## **Technical Memorandum**

### **Background Uranium Concentration**

#### **Homestake Millsite, Grants New Mexico**

Prepared for: Bluewater Valley Downstream Alliance and Multicultural Alliance for a Safe Environment

Figure 16: Uranium concentrations for the Middle Chinle mixing zone wells. Source of data: Homestake digital groundwater chemistry database

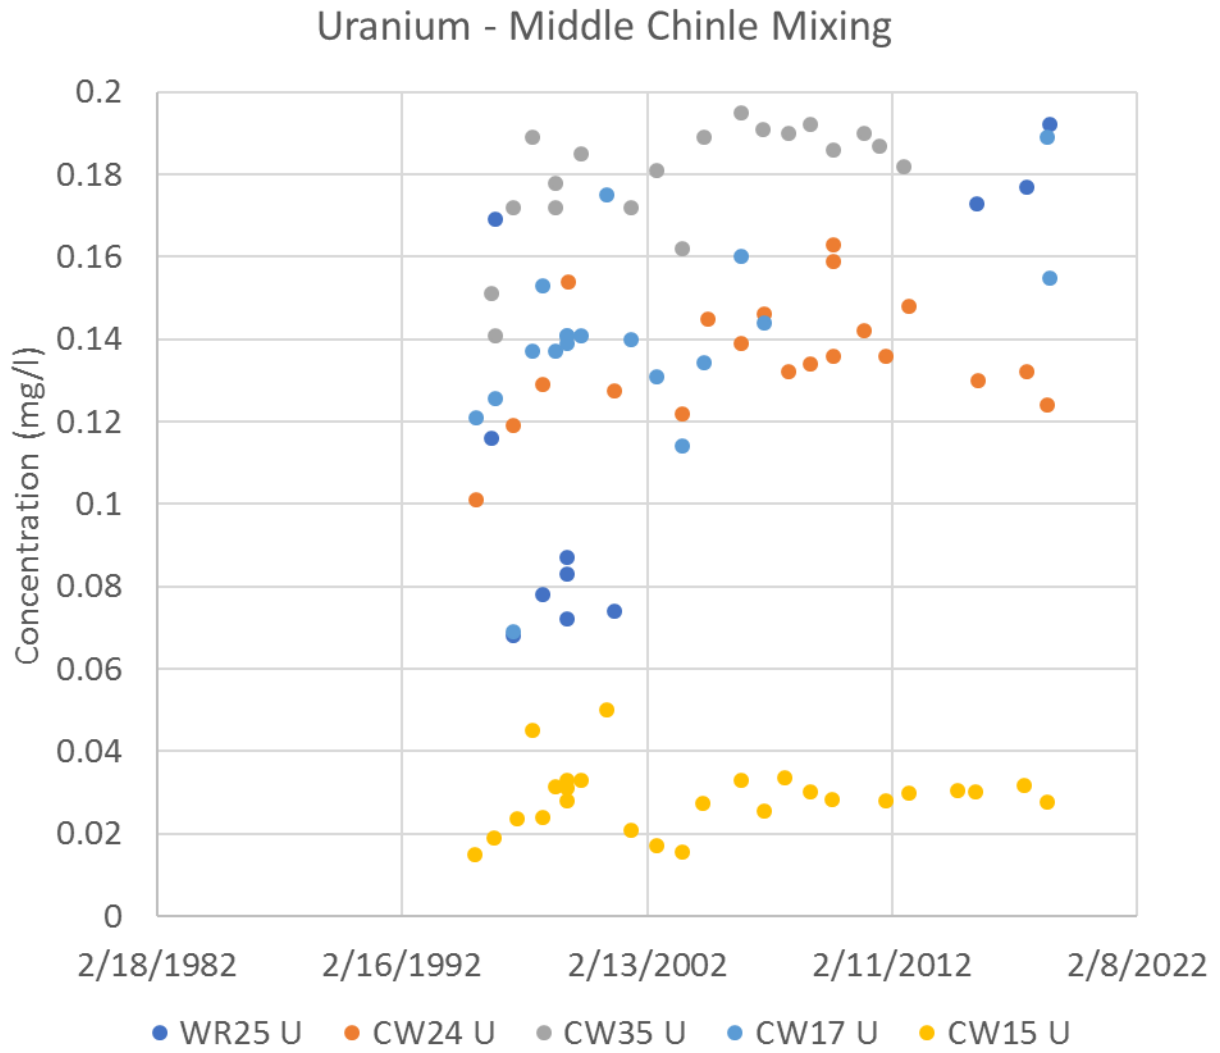
The Middle Chinle has two mixing zones, with one west of the West Fault and one near the subcrop at the southern boundary of the Middle Chinle between the faults. U concentrations at the four wells in the northern mixing zone, WR25, CW17, CW24 and CW35 (Figure 14), exceed 0.06 mg/l with no significant temporal trend (Figure 16). However, these data are more recent than 1992 which suggests that the same source affecting well DD in the alluvium could have affected these wells (Figure 4). All but two observations at mixing zone well CW15 in the southern mixing zone are less than 0.04 mg/l and the two exceptions are less than 0.05 mg/l (Figure 16). The alluvial aquifer over the southern mixing zone is not contaminated.

five wells which also range to almost 0.2 mg/l with no trend from 1992 (Figure 16). The four wells with high concentrations are just west of the LTP near the West Fault (which now may be considered closer to the LTP than it was previously) in the high U flow path (Figure 4). The fault has been considered a pathway to the Chinle and the data confirm that hypothesis. Concentrations for the lower Chinle tend to be less than 0.04 mg/l, with some upward trend starting about 2003 (after the background period and possibly due to flushing at the LTP (HMC 2019)) at CW43 to greater than 0.05 mg/l; this could easily be linked to the earlier high U concentrations in the alluvium near the lower Chinle subcrop.

Figure 20: Uranium concentrations for the Lower Chinle non-mixing zone wells. Source of data: Homestake digital groundwater chemistry database

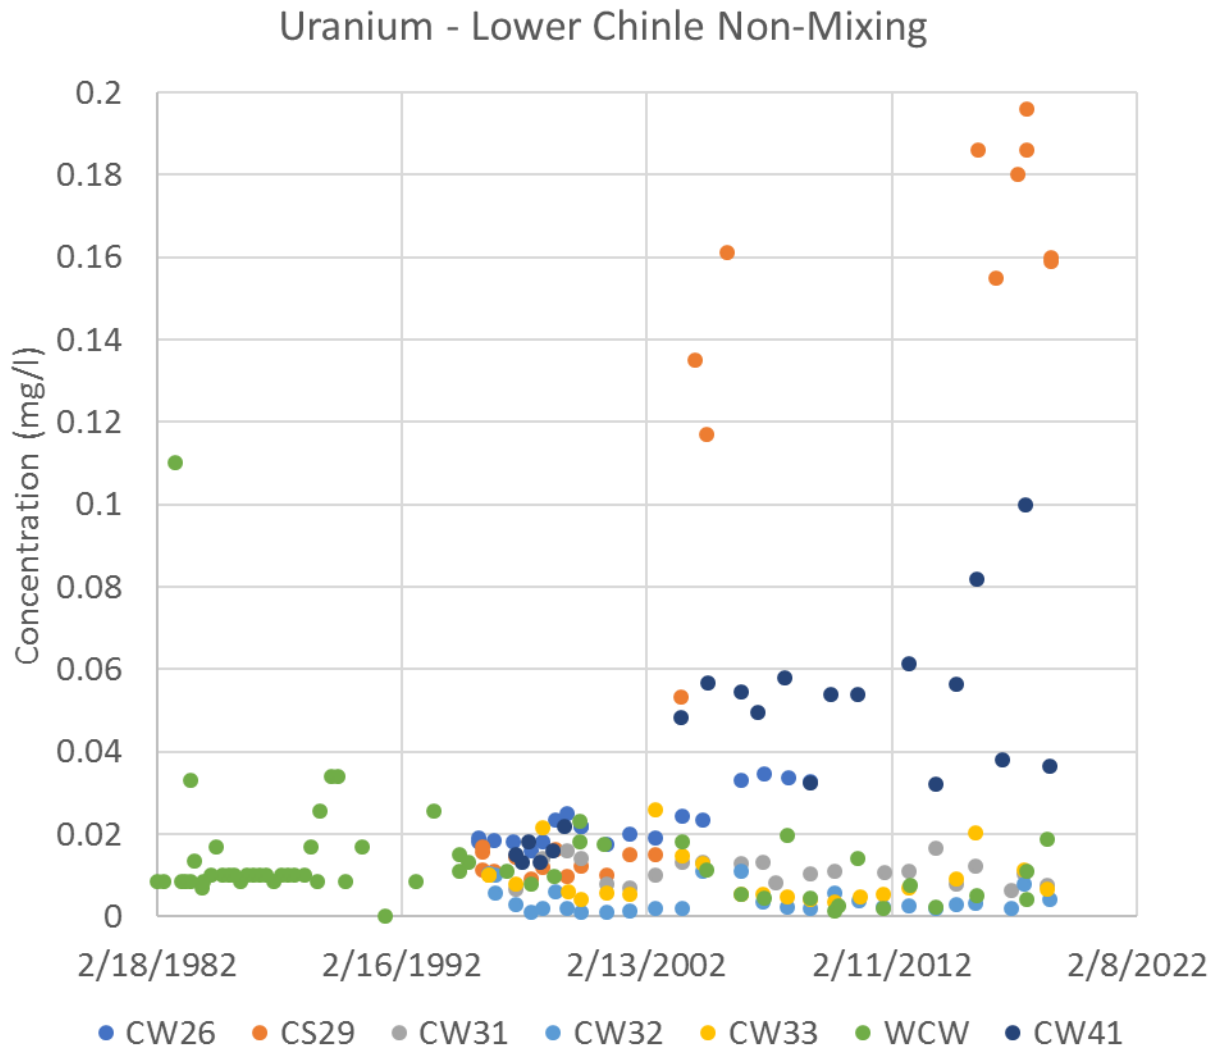
HMC based the background determination for Lower Chinle nonmixing zone on data from 1995 through July 2002. HMC recommended background equal to 0.03 mg/l, with the 95% exceedance equaling 0.02 mg/l (HMC 2015) (Figure 20). Prior to 1995, a few observations slightly exceeded 0.03 mg/l at WCW. Beginning in July 2002, a significant increase commenced with the U concentration in CW29 almost reaching 0.2 mg/l. The mixing zone primarily has concentrations less than 0.03 mg/l, but in well CW43 the concentrations have increased to exceed 0.04 mg/l. Well CW43 is nearest the subcrop over which U concentrations have begun to increase west of the LTP in the paleochannel. Wells CW29 and CW41 are southwest of Felice Acres. Because there are no monitoring wells in the mixing zone south of the wells, it is not possible to track the potential movement of U to these wells from the subcrop. The contamination could result from movement through the East or Middle Faults.

HMC's recommended 0.03 mg/l background is appropriate for the Lower Chinle nonmixing zone.

*Figure 22: Percent exceedance plot for Chinle mixing zone wells not affected by millsite contamination, from 1987 through 2018. Includes wells CW9, CW10, CW50, CS52, CW36, CW37, CW39, and CW15. One observation is off the chart at 0.3 mg/l. Data source: HMC database*

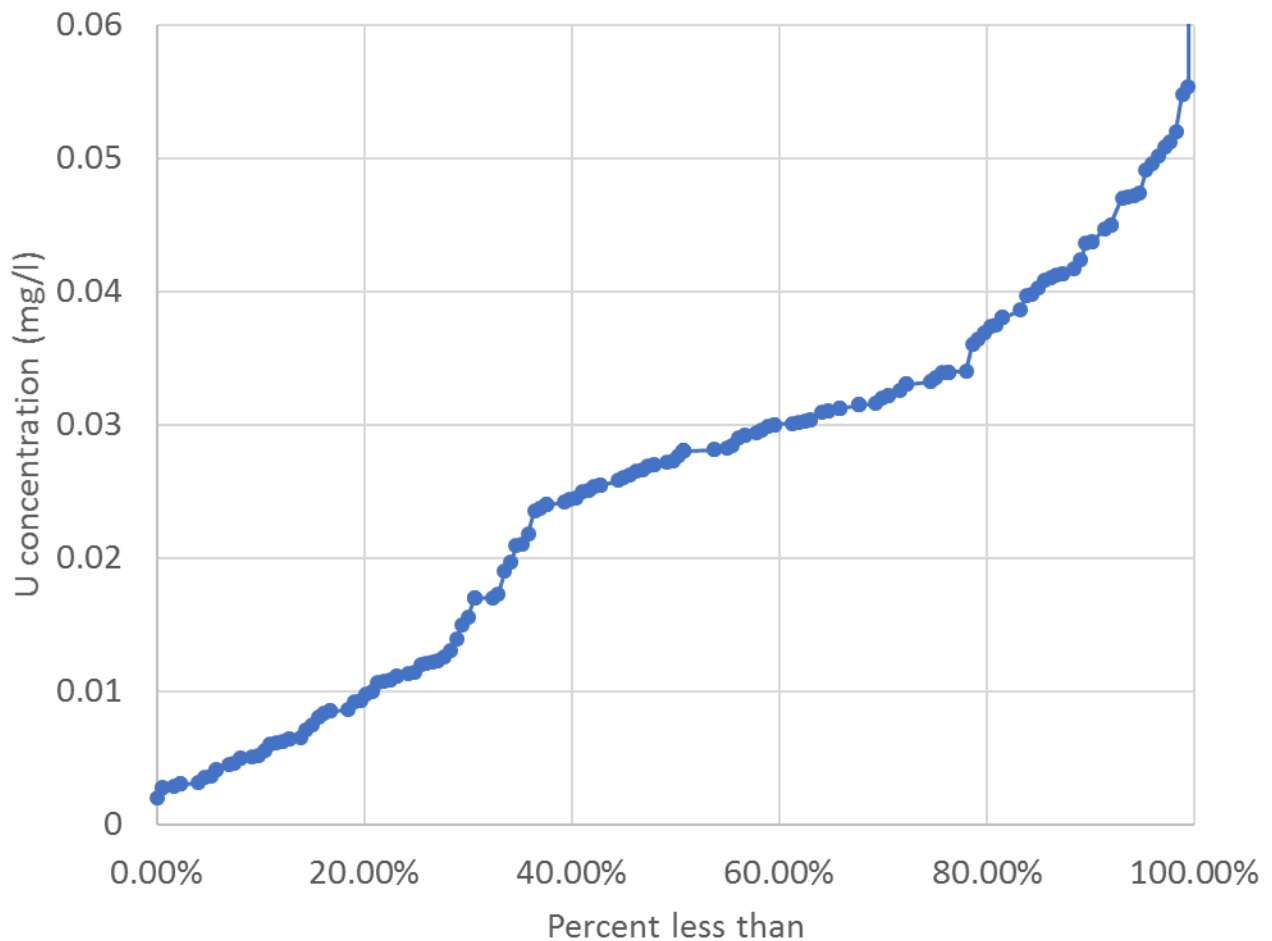
As described, HMC grossly overestimated the background concentrations for the Chinle mixing zones because it included impacted Middle Chinle mixing zone wells. Most U concentrations in the Upper and Lower Chinle mixing zones are less than 0.05 mg/l, the high values in the Middle Chinle mixing zone controls HMC's estimated background. All HMC data from the Upper and Lower Chinle mixing zone and Middle Chinle well CW15 through 2018 are appropriate to consider for background. Extending the data through the present for unaffected wells is appropriate due to the lack of trends. The 95% exceedance is 0.048 mg/l, with the median being 0.0275 mg/l (Figure 22). A fair background level for the Chinle mixing zones is 0.05 mg/l, not the 0.18 mg/l as proposed by HMC. The primary difference is to not consider the Middle Chinle mixing zone wells under the high-U pathway west of the LTP. It is appropriate that the mixing zone has a higher background than the alluvium because it is possible the water attains some U passing into the Chinle.
